PJM TEAC Meeting

2-8-2017

Questions Pertaining to Proposed Projects & Scopes

AEP Transmission Zone

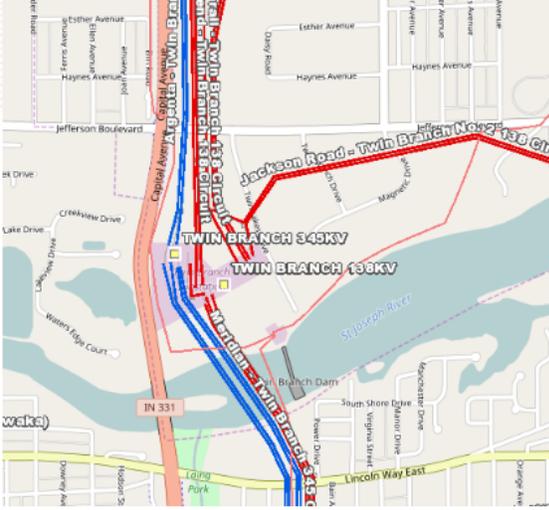
1. How far into the future are PJM short studies currently looking?
2. Are FSA units and/or units not in-service included into the model?
3. What is the CB's capability and duty %
4. With or without Transformer #6 in-service
5. How was the 345kV high side transformer tie modeled in the assessment?
6. Projected project ISD?

BGE Transmission Zone: Supplemental Project Howard and Jericho Park 230 kV Breaker Replacement

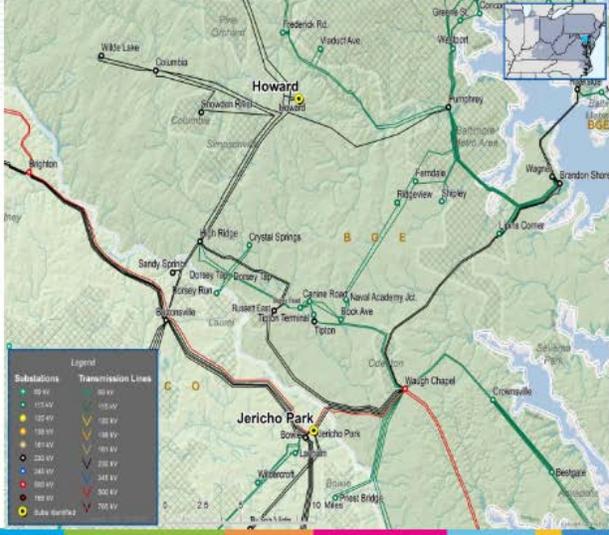
1. What are the ages of the CB's?

2. How many fault and switch operations have the CB had?

3. What type of oil circuit breakers are these and who manufactured them. (GE-FKs)?

4. Does BGE conduct oil testing on CB's, If so would BGE be will to provide the oil sampling data?
